Product Advisory

Whitney+ power reduction configuration support in 2.25

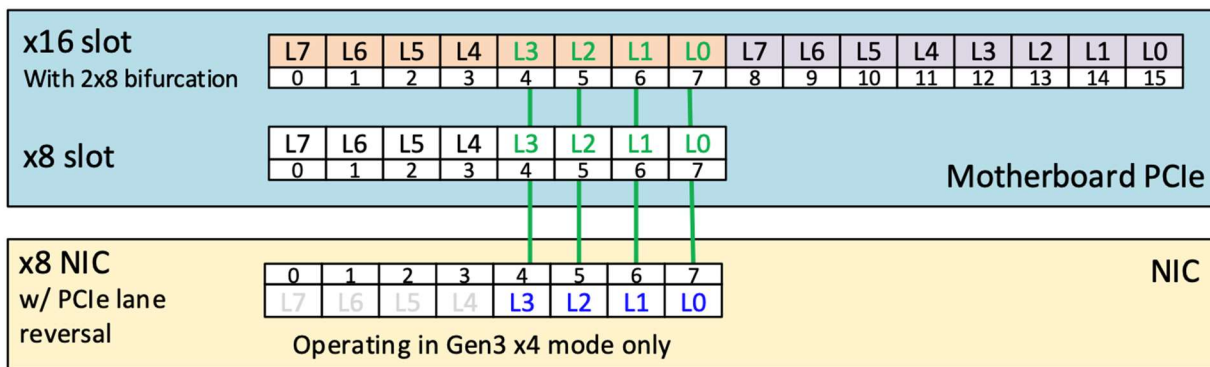
Above listed Broadcom NICs implement PCIe lane reversal (table 1) on the PCB, which may be incompatible with certain motherboards after enabling the power reduction feature. If the feature is enabled on an incompatible motherboard, **the card will not be detected by the host over the PCIe bus.**

Step1: A board listed in table 1 is updated or manufactured with a firmware release in table 2

Step2: Modify the corresponding NVM config item to enable the power reduction feature

Step3: An AC power cycle is required for the change to take effect

Step4: After the AC power cycle, the power reduction feature is enabled

The above sequence of events will result in the card not getting detected on incompatible motherboards. To recover the card, the customer will need to move the NIC card to a compatible system, disable the feature, and then move the card back to the original motherboard.
